Bellingham Planning Commission
210 Lottie Street
Bellingham, WA

RE: RM Zone Project, Draft Ordinance

Exhibit A

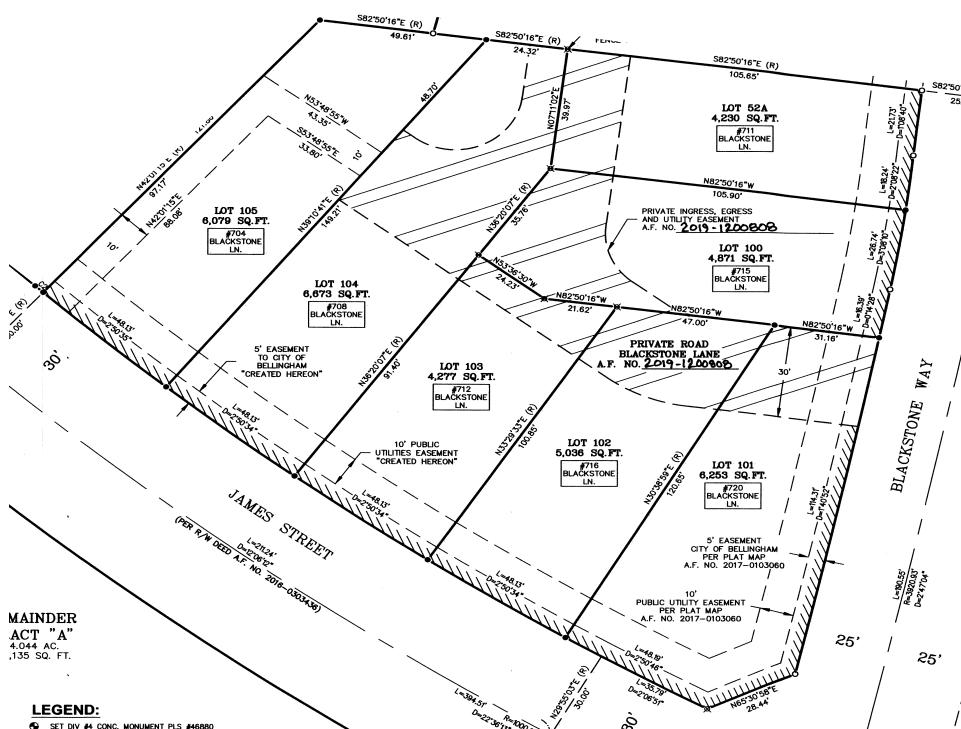
1. **The goal is density-** The purpose of the revisions to the residential multifamily code is to address the areas of RM zoning that have been significantly underdeveloped. Staff was directed to leave “no stone unturned” to achieve densities intended in the Bellingham comprehensive plan. This problem has been corrected by specifically creating minimum density (pages 34-36). The Developer or Builder needs the flexibility to determine based on market demand, financing and other factors the best mix of housing types necessary to achieve the minimum density; the specific housing form is irrelevant if the minimum density has been met. If the goal is to have 6 units on one acre that can be achieved by 6 townhomes, or 6 apartments, or 6 single family homes, etc. Attached as exhibit A is an example of both townhomes and detached single family homes meeting this density requirement. Under the proposed revision the single-family homes would NOT be allowed despite meeting the density requirement. If the goal is density, it should be allowed in all forms.

Exhibit B

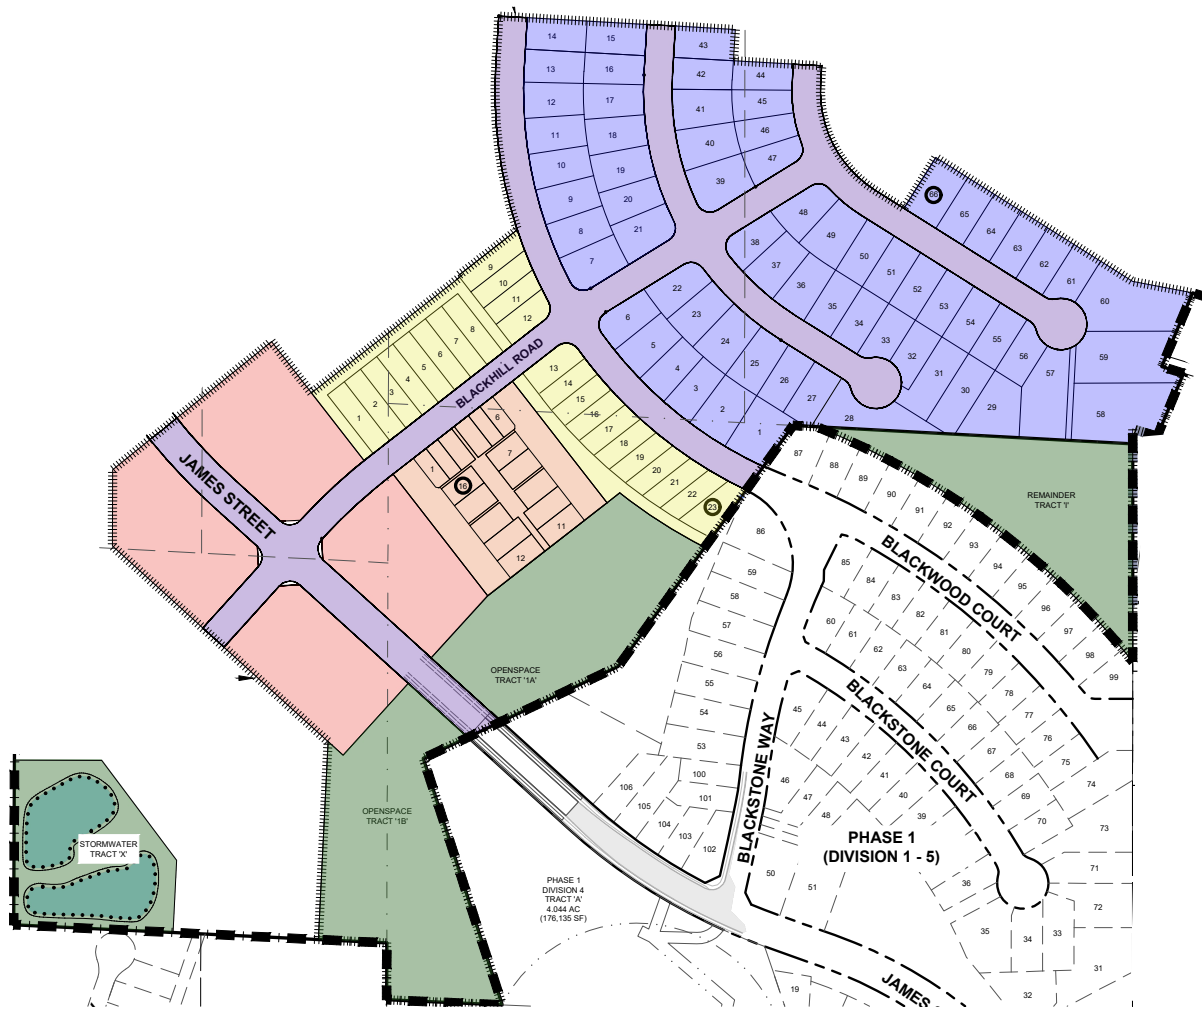
2. **Low housing supply needs to be solved with more flexibility, not less-** The density problem in Bellingham can be solved without eliminating or capping single family homes and still provide multiple housing types. Attached as exhibit B is a proposed plat that has 205 multifamily units, 16 garden court units, and 89 single family homes: totaling 310 units. This plat is another example of using single family to achieve the intended comprehensive plan density and would achieve 10 units per acre; but it would not be permitted under the proposal because 28% of the units would be single family.

1. **Net minimum density is simple to identify-** The size and location of unbuildable areas are easily identified during the platting process by Staff and are usually listed on the plat or in other documents. (see attached Exhibit B table from a current plat
